Intel[®] 82443MX PCIset Specification Update

Release Date: August 2000

The 82443MX PCIset may contain design defects or errors known as errata that may cause the product to deviate from published specifications. Current characterized errata are documented in this Specification Update.

9. C3/POS/STR Memory Hang Condition

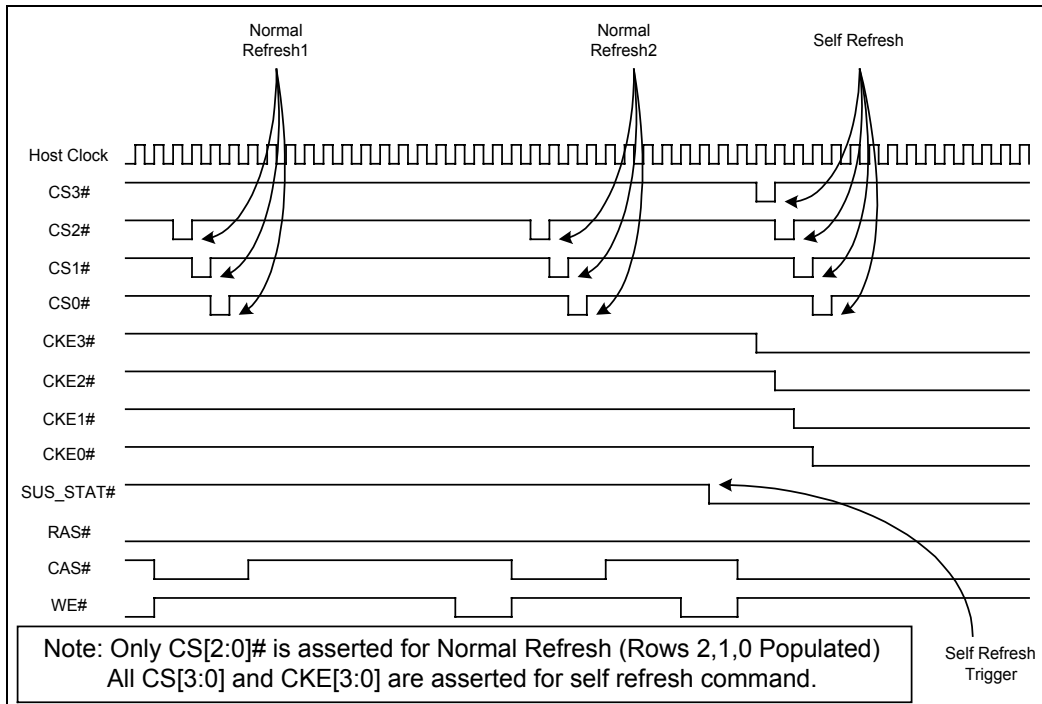
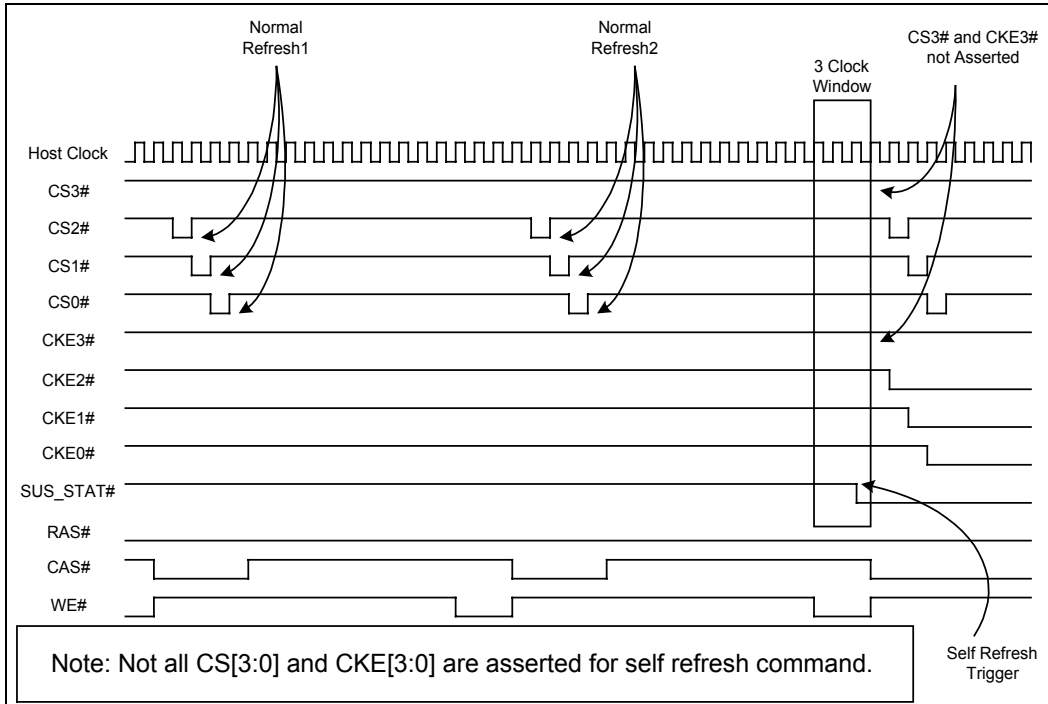
ISSUE: SDRAM may be prevented from being put into self-refresh state when a self-refresh entry request triggered by SUS_STAT# assertion collides with a normal refresh caused by internal timer expiration. The collision between the two requests results in anomalous behavior on the CS[0-3]# and CKE[0-4]#, which can cause the system hang/memory corruption. There is a three Host clock window in which the assertion of SUS_STAT# can cause this failure.

Figure 1 illustrates a successful suspend entry sequence for a system which has rows 0, 1, and 2 populated. Note that for normal refresh, only the chip selects for the populated rows are asserted, whereas for the self-entry command, all four chip selects are asserted regardless of its population. Assume that dynamic SDRAM power-down feature is disabled. If all four rows are populated, it is impossible to capture this erratum.

Figure 2 illustrates an unsuccessful self-refresh entry sequence. Note that SUS_STAT# is being asserted approximately the same time that the third normal refresh would have taken place. Since the SUS_STAT# assertion hits the three host clock window, CS3# and CKE3# do not get asserted during the self-refresh entry sequence.

IMPLICATION: The system may hang if an unsuccessful self refresh entry sequence occurs.

WORKAROUND: Please refer to the SDRAM Suspend Refresh Erratum APM Workaround Write-up, Rev 1.0 for a software workaround solution.

STATUS: Fixed in B-0 stepping.

33. USB Connect Status Change Bit does not get set under certain conditions

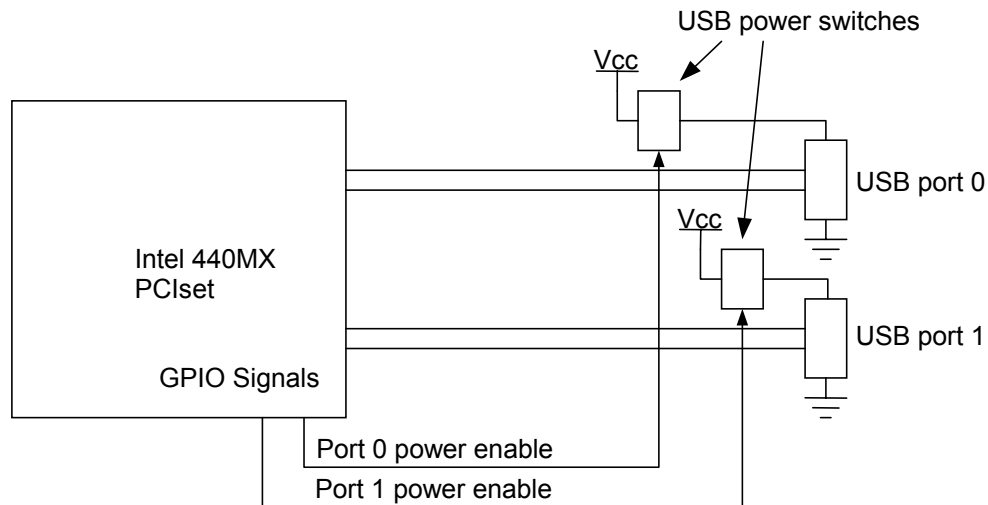
ISSUE: When system is in S0 state with CLKRUN# enabled and PCI bus is idle (and hence STP_PCI# is asserted), the USB Connect Status Change Bit does not get set.

When CLKRUN# is enabled (<PM base>+10h bit 13 set). Enable device IO trap (Assuming device 12 is used).

- Clear EIO_EN_DEV12 (dev7 func3 PCI 5Ch bit 29)
- Set IBASE_DEV12 (dev7 func3 PCI 68h bits 0-15) to USB base address+10h
- Set IMASK_DEV12 (dev7 func3 PCI 68h bits 16-19) to 3
- Set IO_EN_DEV12 (dev7 func3 PCI 68h bit 20)
- Set <PM base>+2Ch bit 24
